Access Compliance Report

Public Rights-of-Way

(Curb Ramps)

Intersection ID: 2527	Main Street: CAMBRIDGE_BAY_DR	Cross Street: LAGRANDE_DR	Location: NW
ADA ID: D830AFDD7C16	Ramp Type: PerpDiag	Initial Pass/Fail: Fail	Overall Compliance: No
Severity Score: 10			
Codes/Mitigation Info/Possible Solution		Field Measurements/Component Compliance

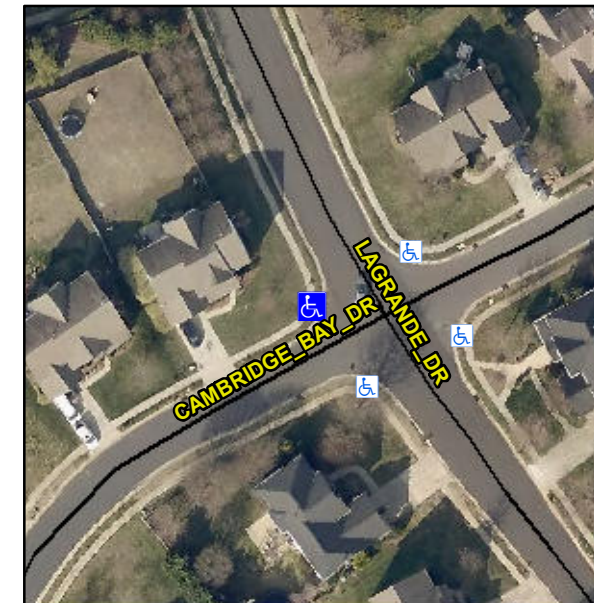
Compliance	Description	Data	Compliance	Description	Data
N/A	Ramp Length (in)	48.0	Yes	Ramp Slope (%)	5.9
No	Ramp Width (in)	43.0	No	Ramp XSlope (%)	3.8
N/A	Flare Type LT	N/A	N/A	Flare Type RT	N/A
N/A	Flare Slope LT (%)	N/A	N/A	Flare Slope RT (%)	N/A
N/A	Flare Traversable LT?	N/A	N/A	Flare Traversable RT?	N/A
N/A	Landing Length (in)	N/A	N/A	DWS Provided?	N/A
N/A	Landing Width (in)	N/A	N/A	DWS Contrast?	N/A
N/A	Landing Slope (%)	N/A	N/A	DWS Length (in)	N/A
N/A	Landing X Slope (%)	N/A	N/A	DWS Full Width?	N/A
N/A	Landing Curb? (Y/N)	N/A	N/A	DWS Offset (in)	N/A
N/A	Shared Landing?	N/A			
N/A	Gutter Ponding?	N/A	N/A	Gutter Slope (%)	N/A
N/A	Gutter Lip Ht (in)	N/A	N/A	Gutter X Slope (%)	N/A
N/A	Painted X Walk1?	No	N/A	Painted X Walk2?	No
	X Walk 1 Direction	To S		X Walk 2 Direction	To E
N/A	X Walk 1 Width (in)	N/A	N/A	X Walk 2 Width (in)	N/A
	X Walk 1 Slope (%)	0.8		X Walk 2 Slope (%)	3.9
	X Walk 1 X Slope (%)	4.2		X Walk 2 X Slope (%)	0.4

N/A	Ramp inside XWalk1?	N/A	N/A	Ramp inside XWalk2?	N/A
	Road Slope (%)	2.5	N/A	Clear Space?	N/A
	Road X Slope (%)	2.8	N/A	Clear Space to XWalk (in)	N/A
N/A	Any Obstructions?	N/A	N/A	Storm Grate/Utility Hazard?	N/A
	Obstruction Type			Storm Grate/Utility Type	
		N/A			N/A
		Yes		Surface Condition? (G/P)	Good

Remove & Replace Curb Ramp With Two New Directional Ramps or Equivalent.
